Booth Trailer Parak

Re: Approval of Plans and Specifications
for Booth Mobile Home Park, West 8th
and Spring Street, Bloomington,
Monroe County

Re: Proposed Booth Mobile Home Park
West 8th Street & Spring Street
Bloomington, Monroe County

TYPE A TYPE B DETAIL OF WATER RISER PIPE

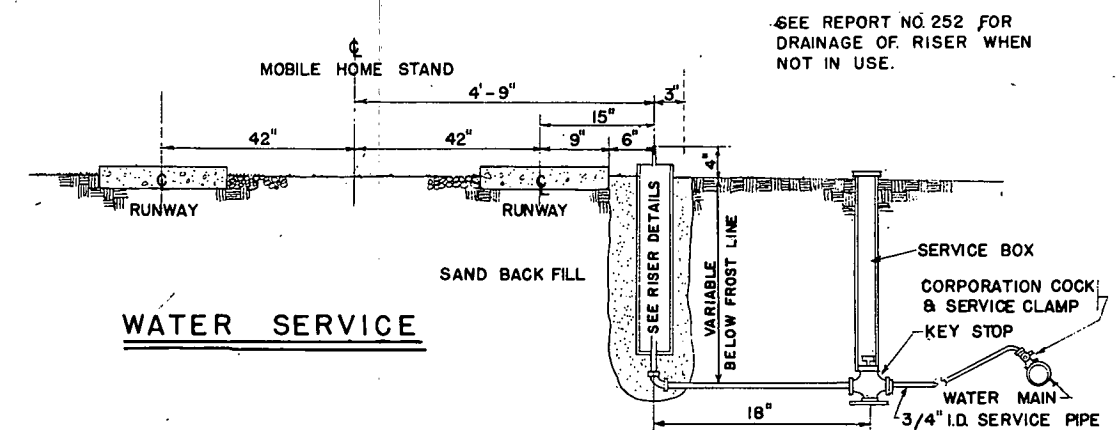
1. Materials used for streets is not specified. Sufficient explanation is necessary to indicate how streets will be maintained so as to be dust proof (Section 21 of Mobile Home Park Law). ✓
2. A description of auto parking is necessary. (Section 21 of Mobile Home Park Law). ✓
3. The detail of the water service connections is incomplete. The water service should extend at least 4 inches above the ground surface. (Section 26 of Regulation HSE 21). ✓
4. The location of the water service connection and sanitary sewer connection on a typical lot should be shown on plans. The end lots and odd shaped lots should also be shown. These connections must be at least 5 feet apart. (Section 27 of HSE 21). ✓

SEWER RISER PIPE, SEWER LATERAL AND SEWER CONNECTION DETAIL

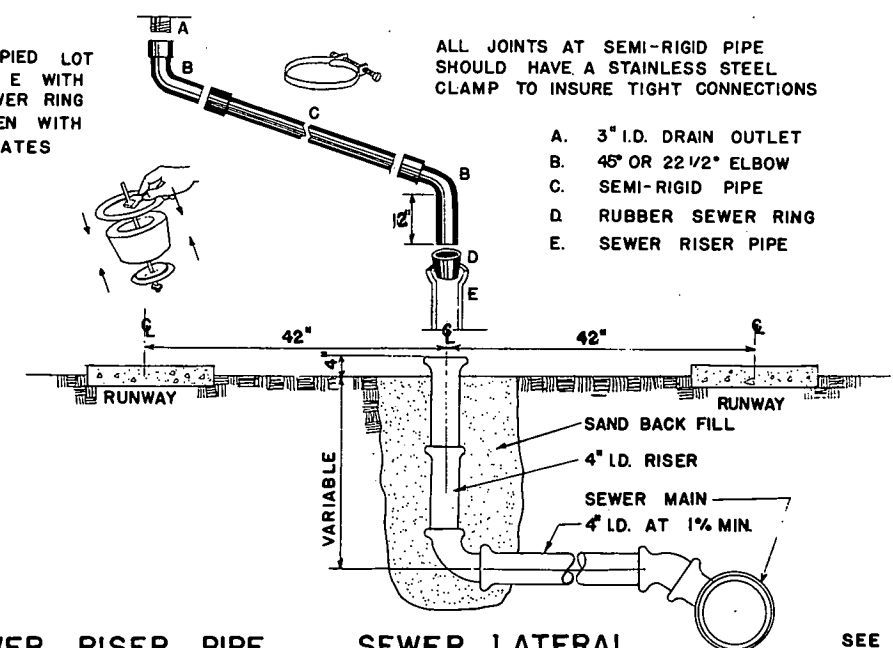
5. Details should be shown of a typical sewer connection.
6. The plan for storage and disposal of garbage and refuse shown be outlined. (Section 37-43 of Regulation HSE 21).
